SR-2 – ADVISORY STAFF REPORT (03-06-2026)

ADDRESS: 1528 WOODWARD

APPLICATION NUMBER: HDC2025-00747

SCOPE: INSTALL SIGN

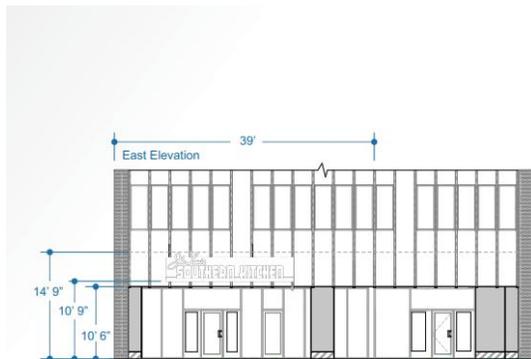
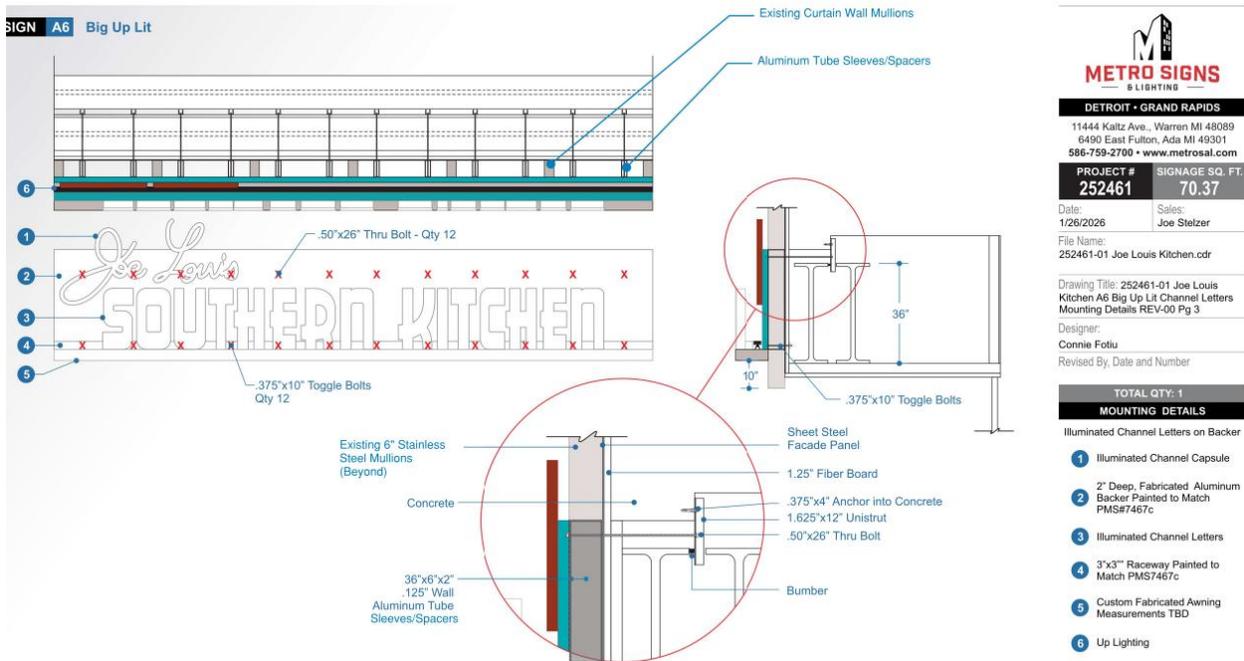
- See the below images from the application to note that the new sign will measure 4’-3” in height and 17’-11” in length. It will include an aluminum backer panel to which aluminum channel letters with acrylic faces shall be mounted. Each letter will be internally lit. A 10” deep aluminum “awning” with up lights will be line the bottom of the sign. The sign will be affixed to the building via twenty four (24) bolts which will be driven into the façade’s porcelain spandrel panels, according to the applicant. Note that he states that no bolts will be driven into

the building's stainless steel mullions/ribs. Also, note that Element of Design # 15 states that signage is typically located...in a panel designed for such purpose..." Staff notes the following issues with the sign:

- The panel will cover a 4'-5" x 17'-11" portion of the façade, obscuring the distinctive historic character-defining architectural elements behind it. The total panel size is nearly 81 square feet in area.
- As the façade lacks a natural/traditional "sign band" area, it is staff's opinion that the sign will sit awkwardly on the façade in a manner which is not compatible with the building's historic appearance

Staff therefore recommends that the Commission deny this scope item.

- A compatible redesign of the signage might be letter or symbols *without* a backer panel, allowing the distinctive architectural elements of the façade to be readable behind the sign. This approach is observed in the United Foundation (“UF”) sign visible in the 1960 architect’s rendering by Diehl and Diehl, visible on page 4 of this report.
